**SAND CREEK RESTORATION**

**GENERAL NOTES**

SHEET 2 OF 99

**DEMOLITION PLANS**  
EX STA: 38+00.00 TO 68+00.00  
SCALE: 1"=100'

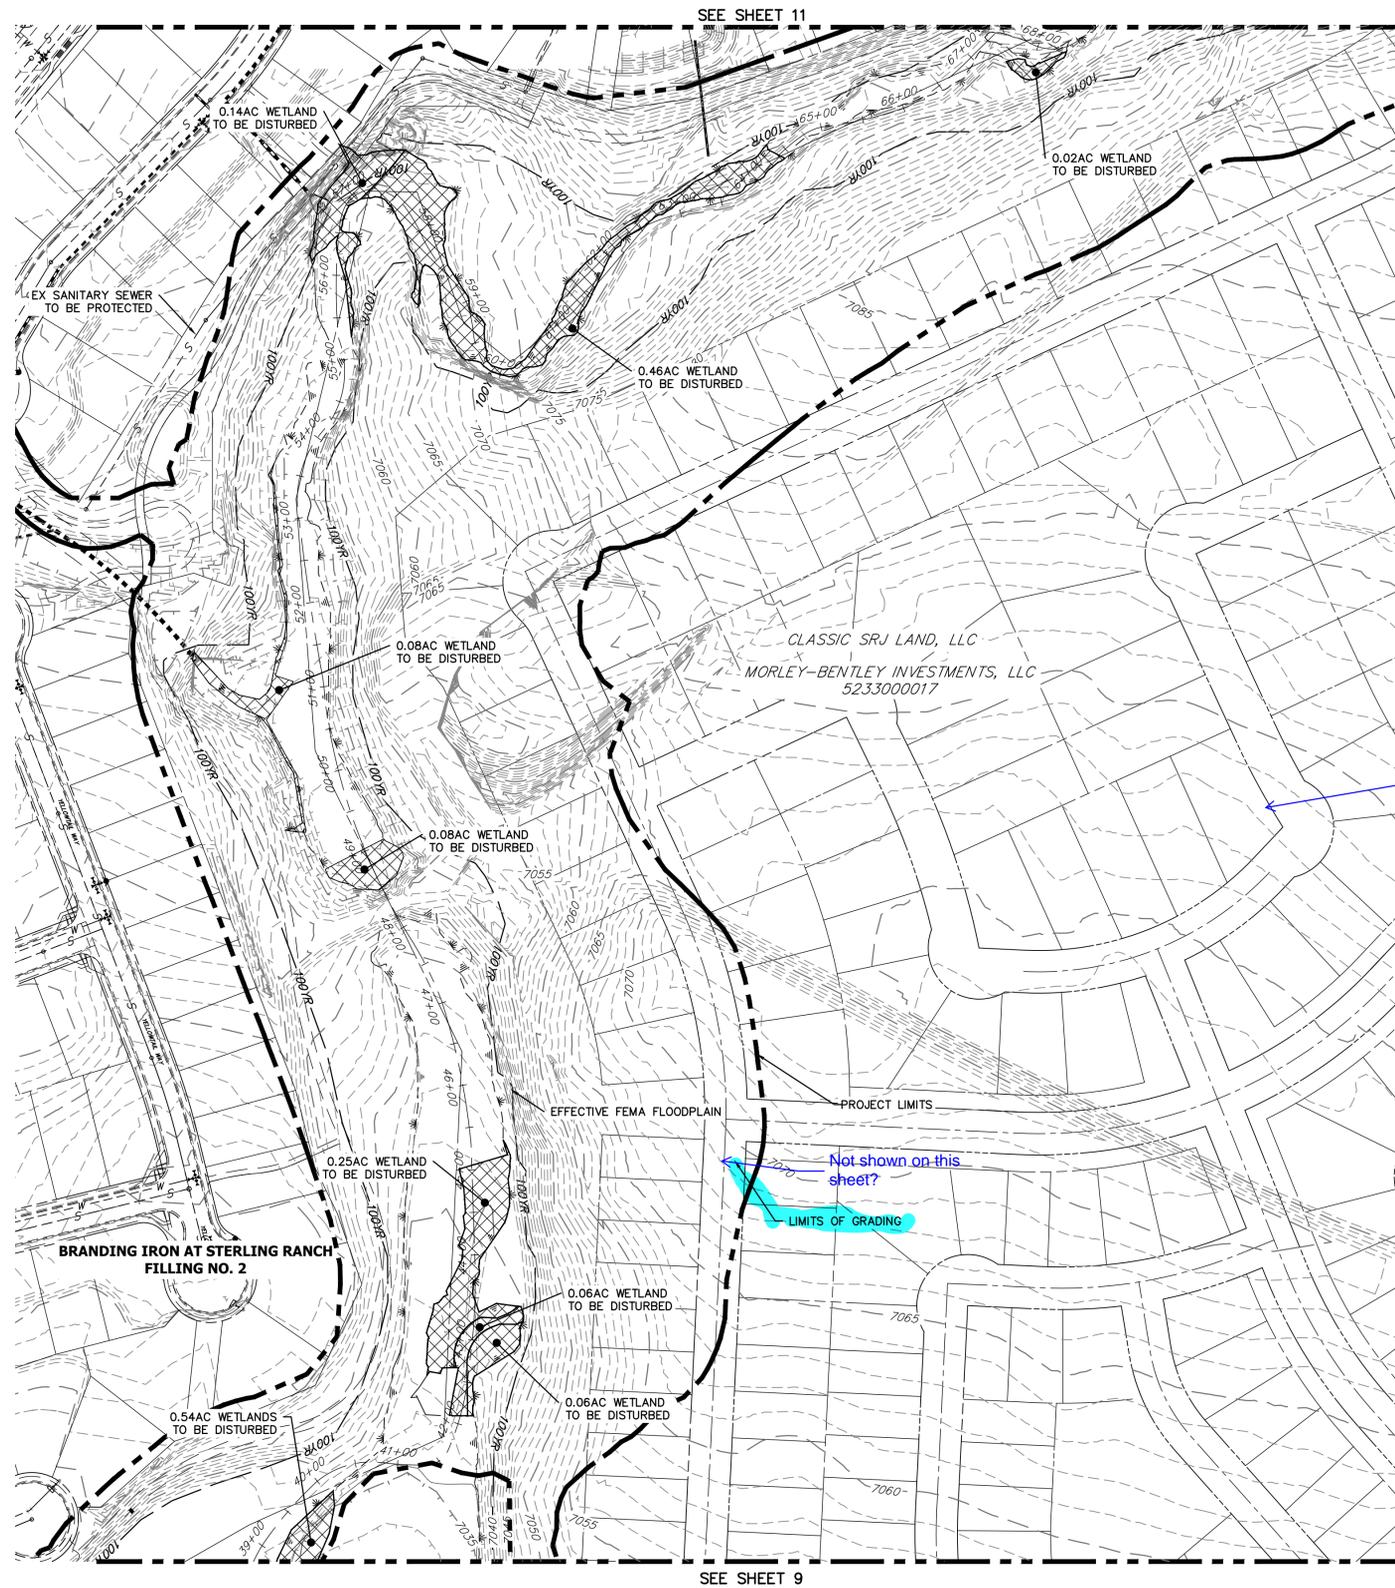
Turn off future lots or label and add a note that these are not approved.

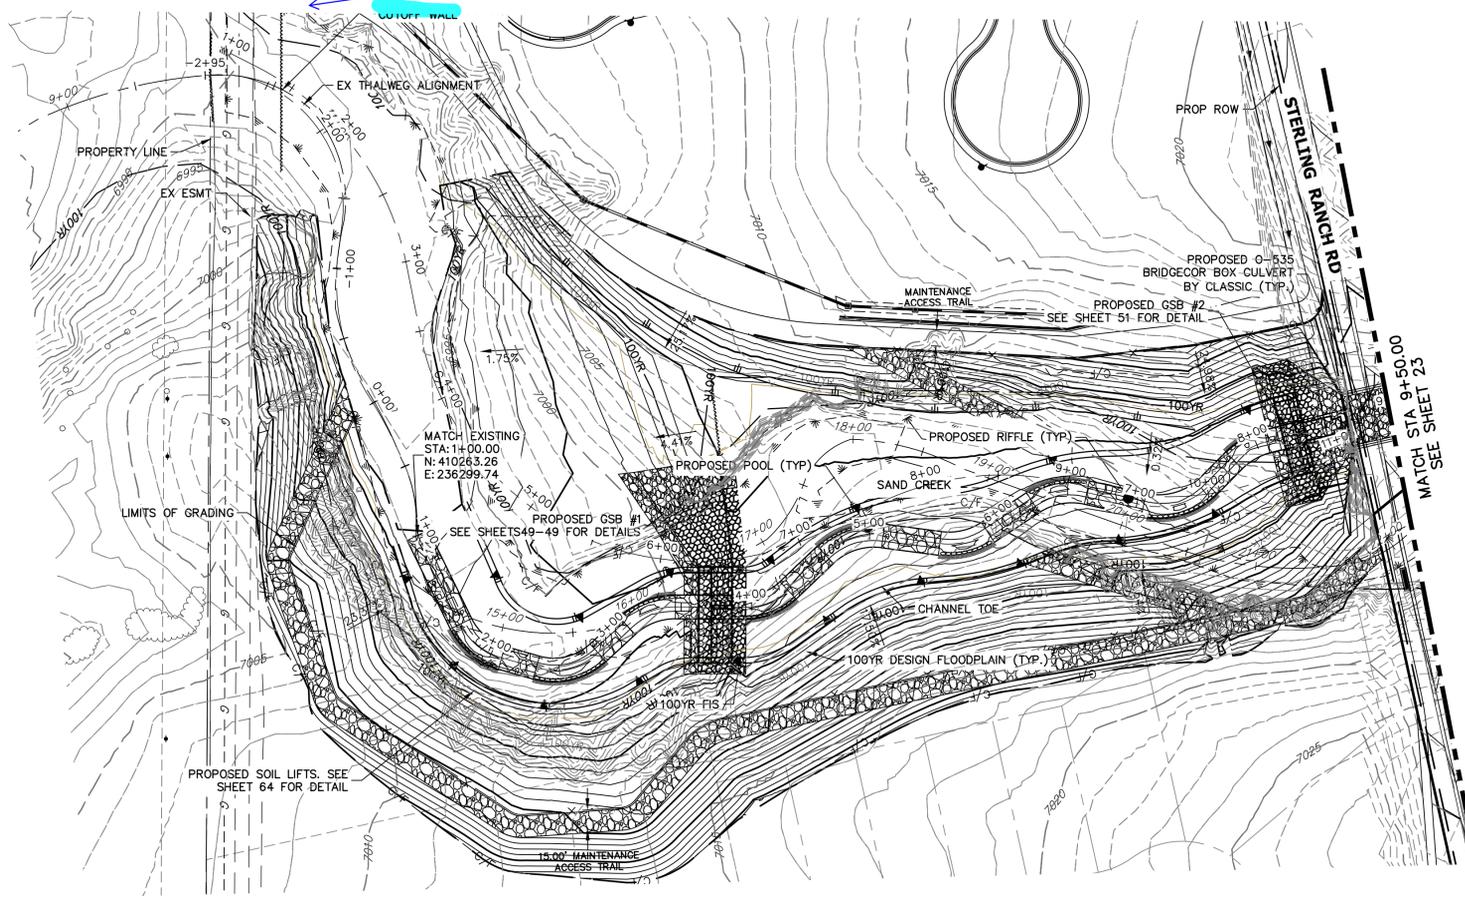
Adjust viewport

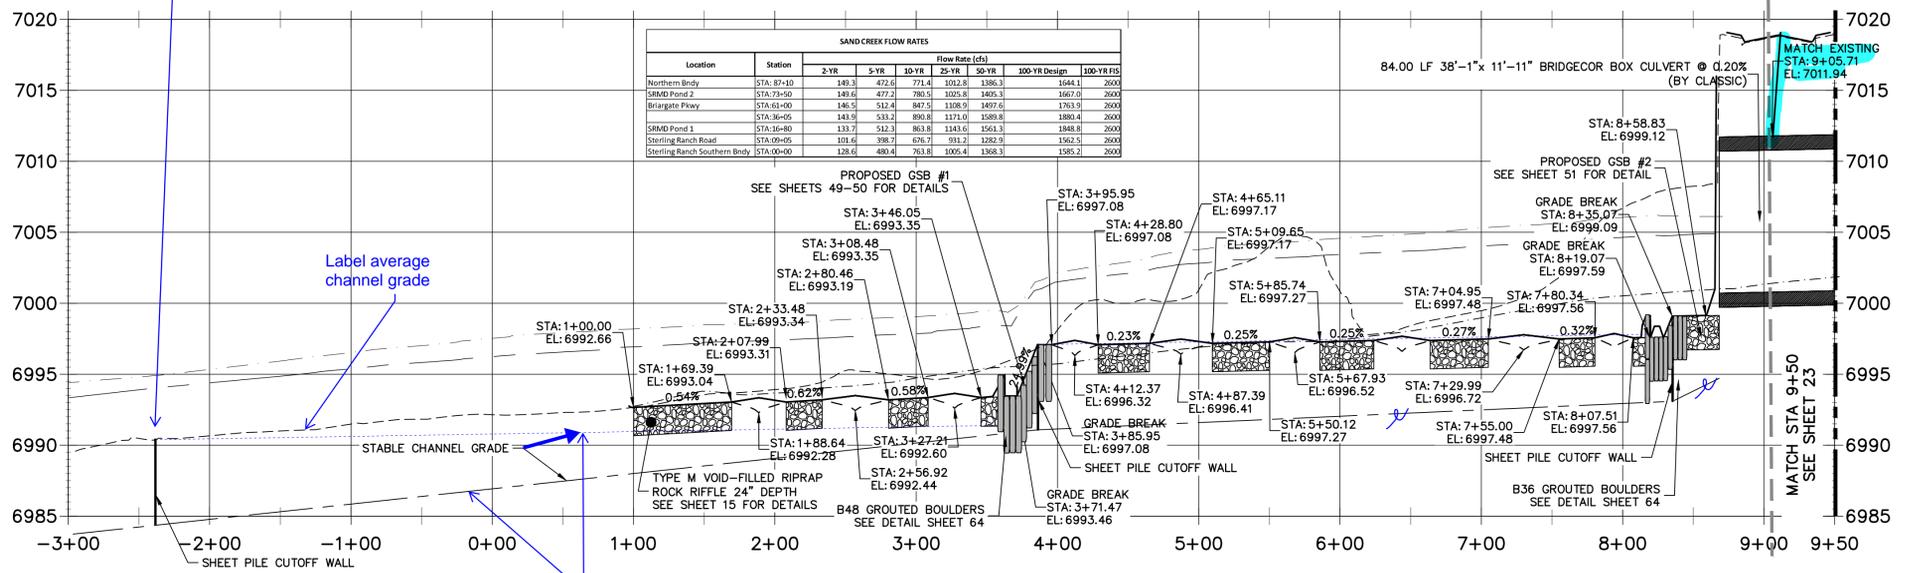
Show property line and utilities

delete gray line?

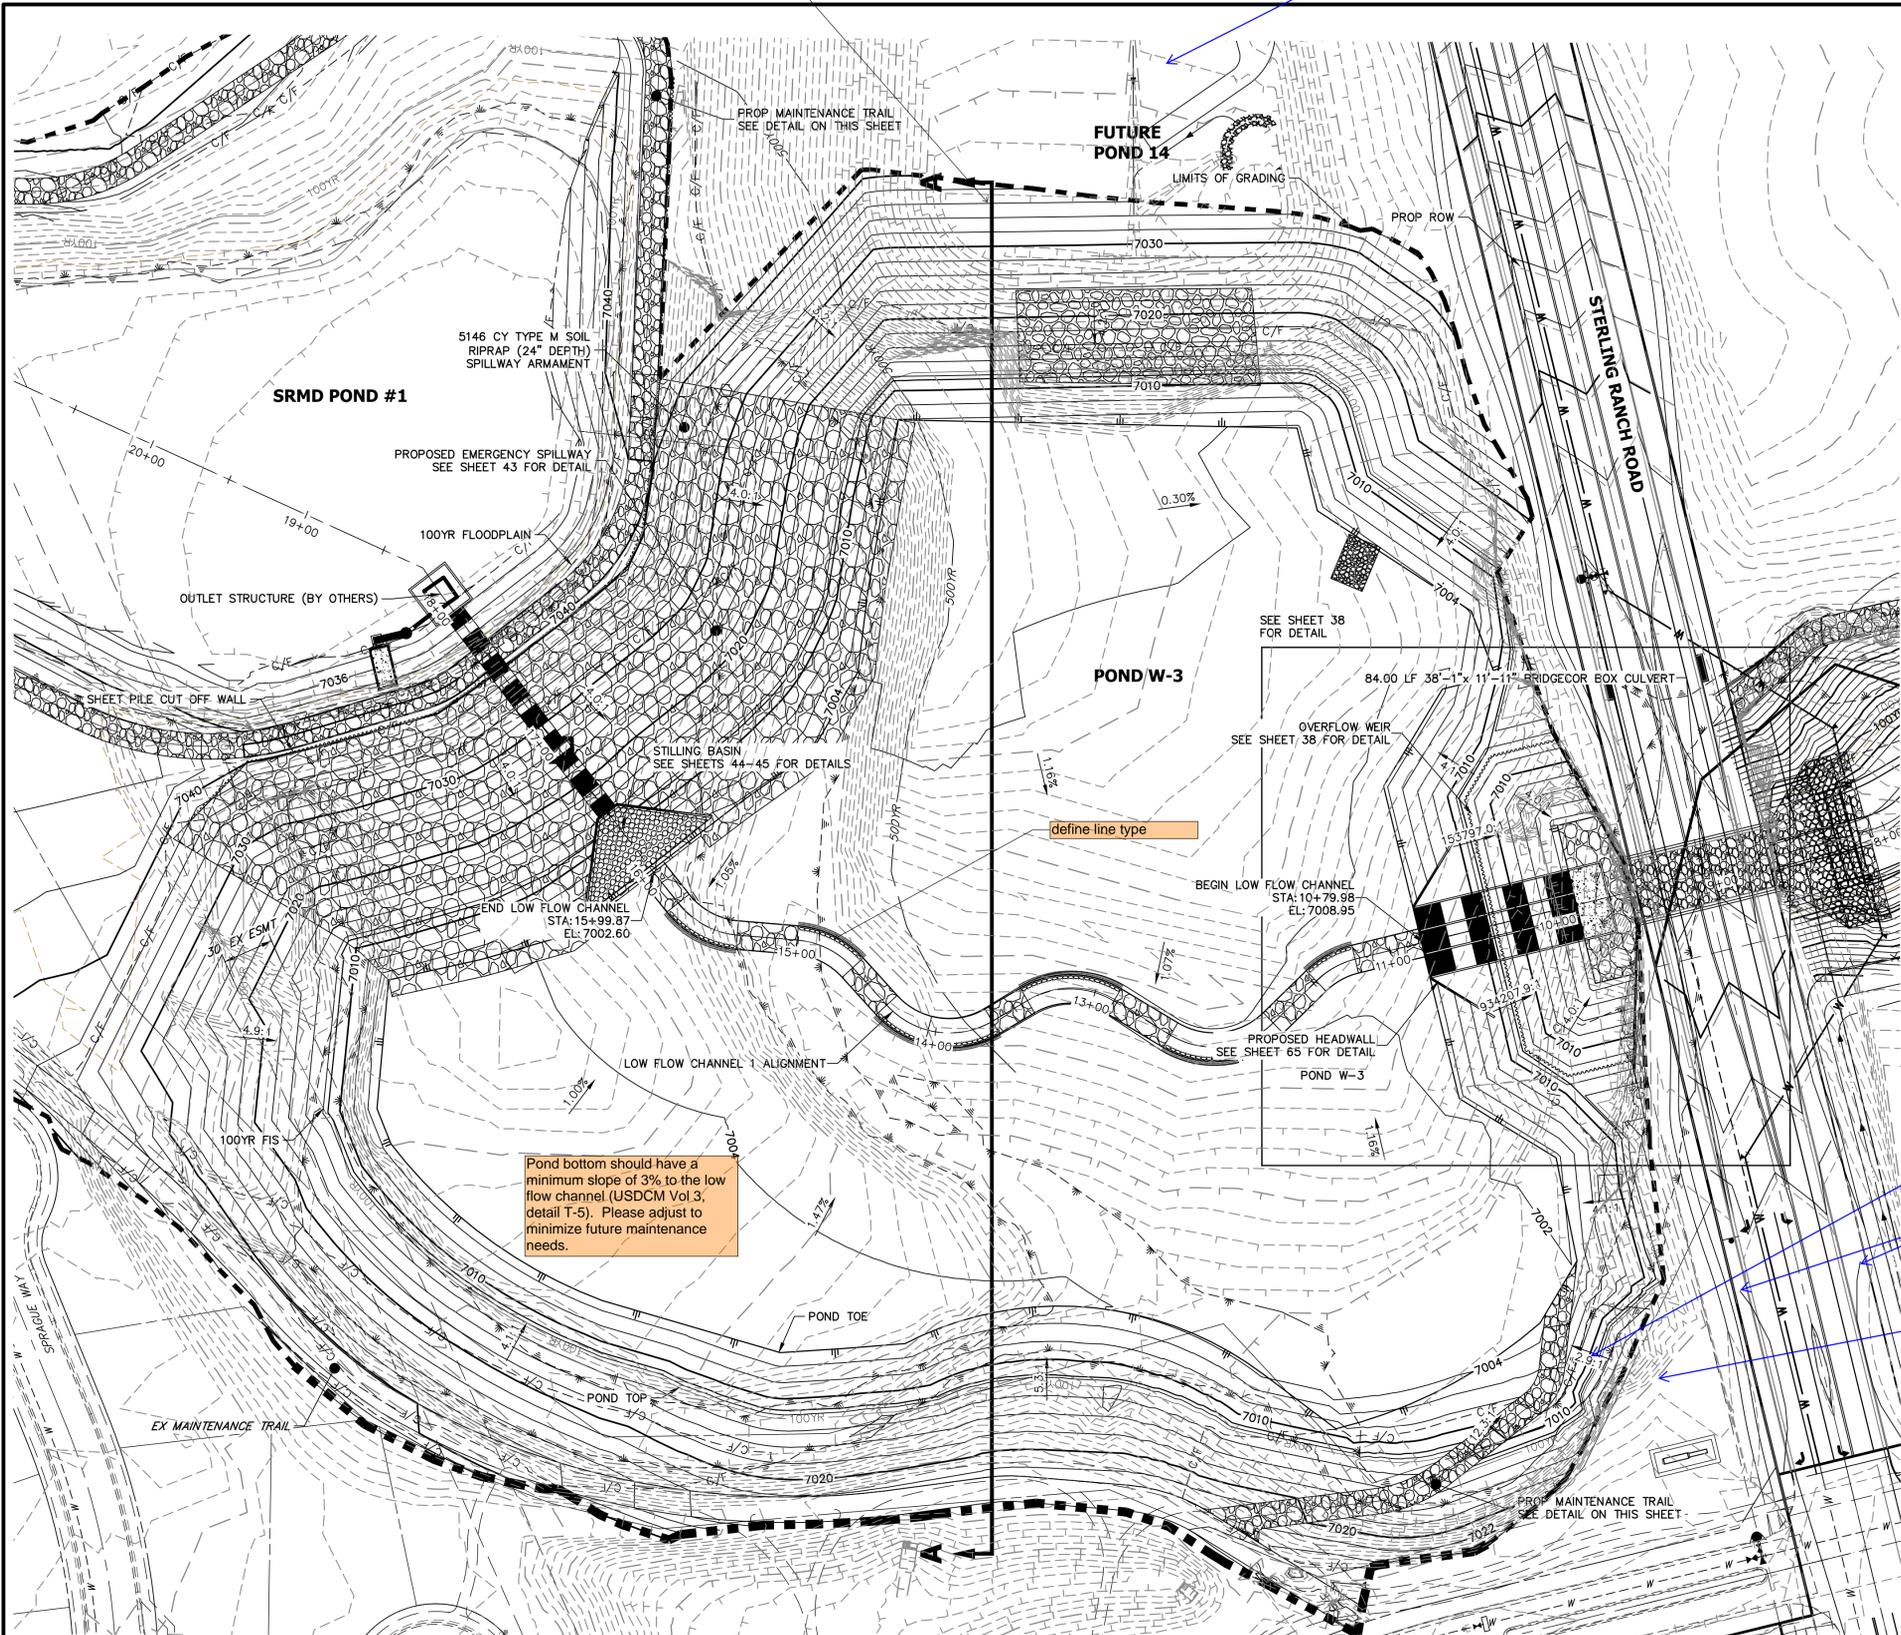
Pond bottom should have a minimum slope of 3% to the low flow channel (USDCM Vol 3, detail T-5). Please adjust to minimize future maintenance needs.

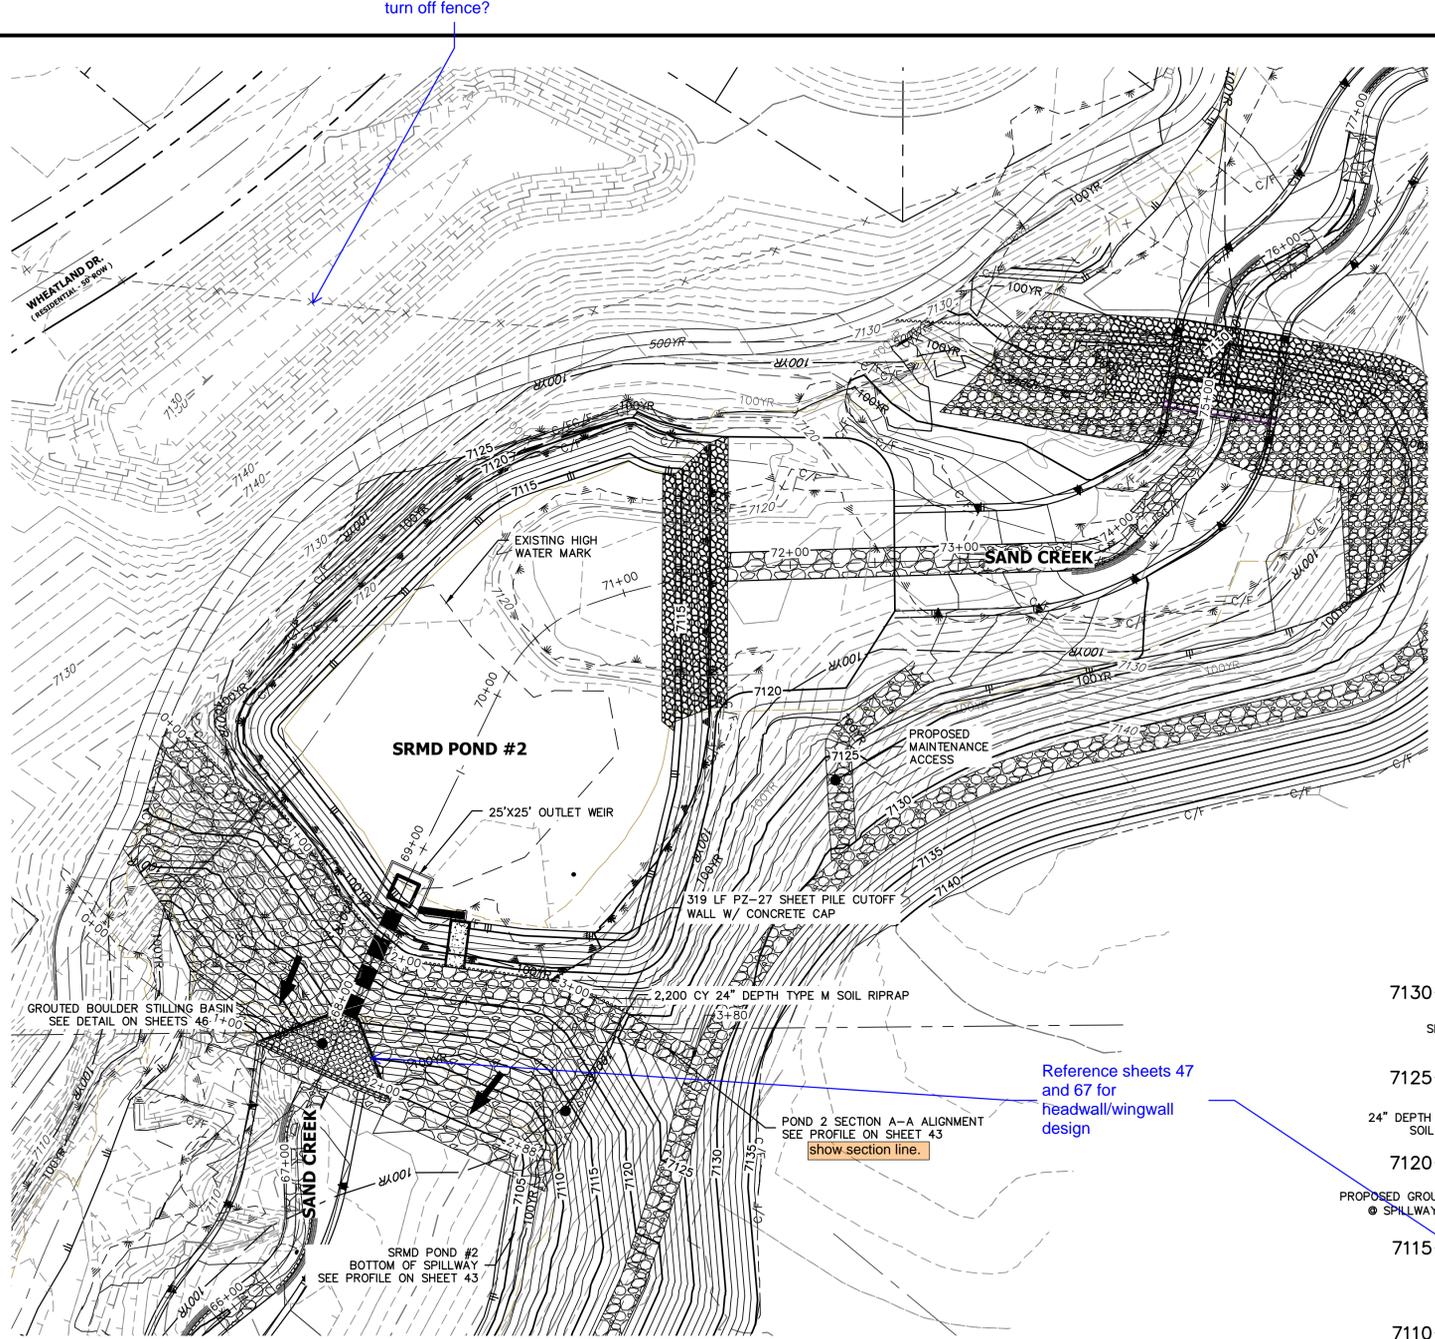
Please be consistent with pond labels. Right now they are labeled SRMD Pond #, Stock Pond #, Existing Stock Pond #, and Pond #

SHEET PILE 1 PROFILE  
STA -1+85.99 TO 0+63.12

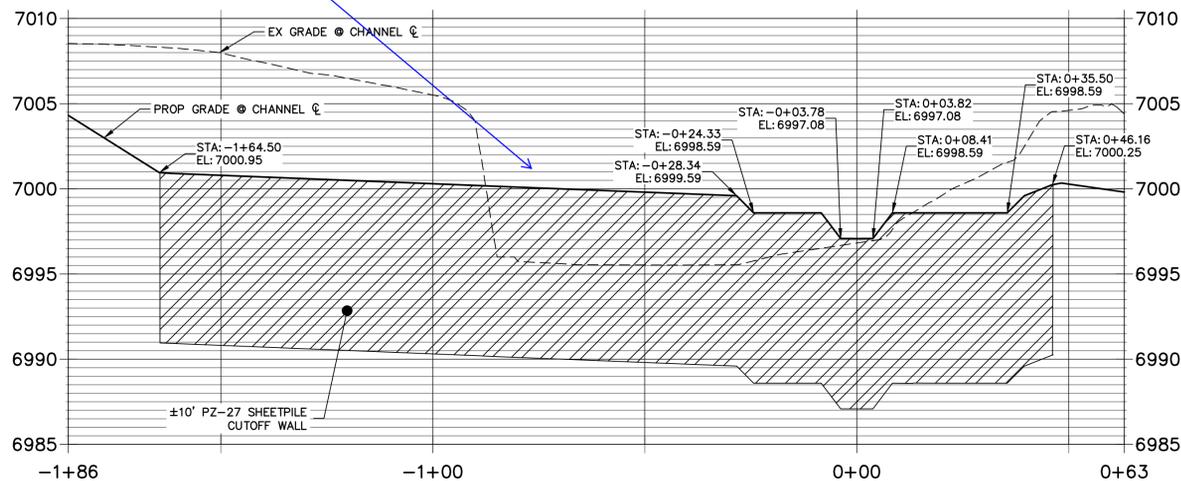
Please show  
100-year WS on all  
8 cross-sections

SHEET PILE 5 PROFILE  
STA -1+32.40 TO 1+27.04

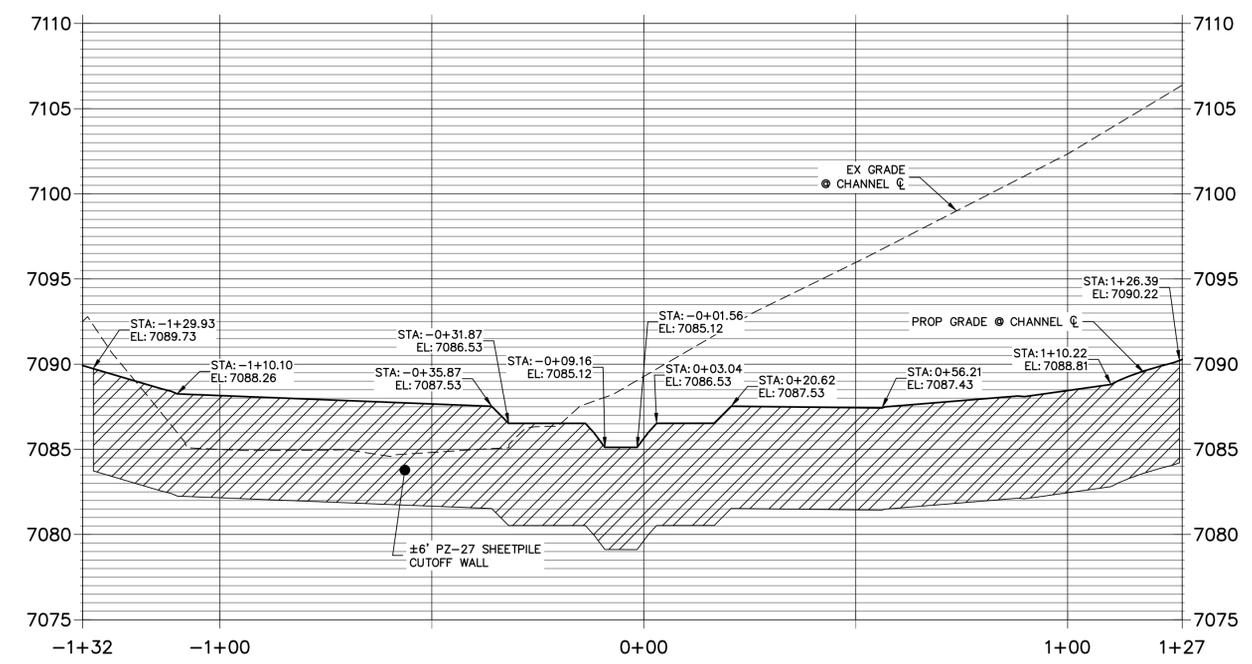
call out trail type and provide/reference detail
